The RadioActivist Campaign

Comment: to the Blue Ribbon Commission (BRC) of the DOE

Title: **Concern for unassessed, local failure of a repository in salt**

July 21, 2010

Fig. 5. Mean total risk probability of release R [from Nelson, p. 18].

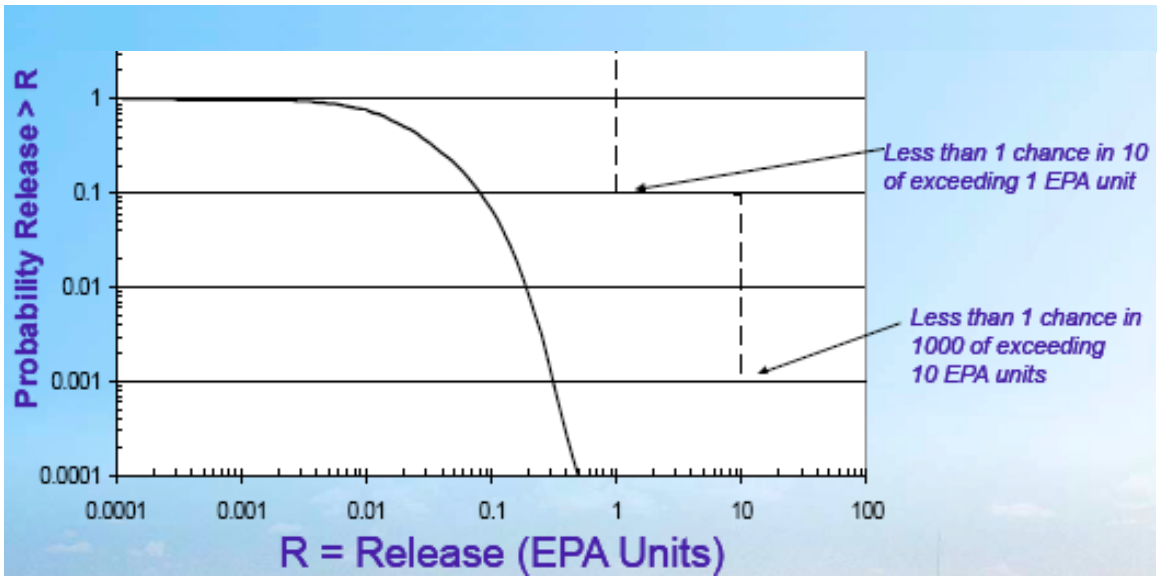
The risk models show that probabilities of releases from Undisturbed Performance (no human intrusion) of the repository are below concern; that is, total risks for all undisturbed scenarios are to the left and below the area shown in Fig. 5. Thus, WIPP claims "no release" from any and all scenarios not involving human intrusion [Nelson, p. 22].

Notice the steep slope of the total risk probability curve, close to the upper step of the EPA Containment Requirements, on the right of Fig. 5. This steep slope means that adequacy of containment is much more sensitive to the magnitude of modeled release than to the modeled probability of a release occurring.

Fig. 6. Side View of the Elements and Material Regions for Modeling Undisturbed Performance [DOE/CCA, Fig. 6-13].

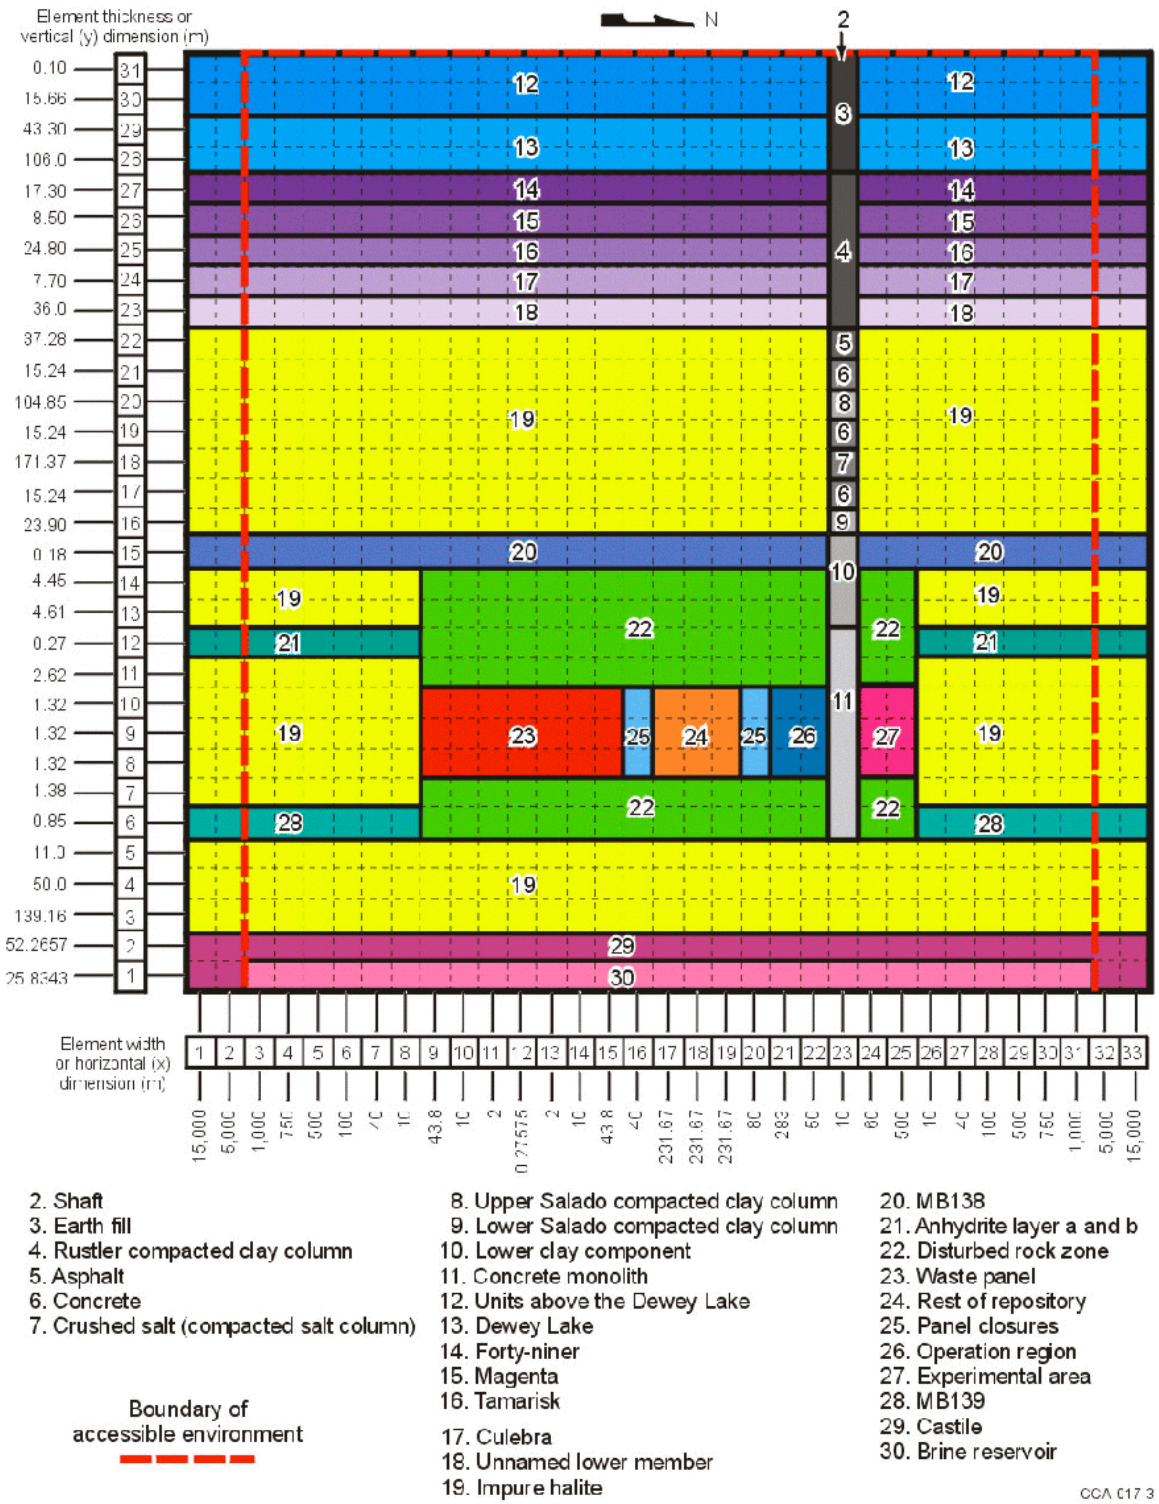
From the standpoint of numerical modeling, consideration of local scenarios would entail reducing the grid scale for the repository (Region 23), the disturbed rock zone (Region 22), and the surrounding, impure halite (Region 19), illustrated in Fig. 6.

Such small-scale modeling would distinguish the locations where the desiccant boxes are placed on the waste stacks and how the desiccant might spill as in-creep of the halite breaks the boxes. Likewise, various heights of pore brine seepage into the creep-collapsed repository might be included in the small scale of such a PA model.

Based on my limited consideration of scenarios, here, I believe that such a local-source PA should be run, along with a sensitivity analysis of it.
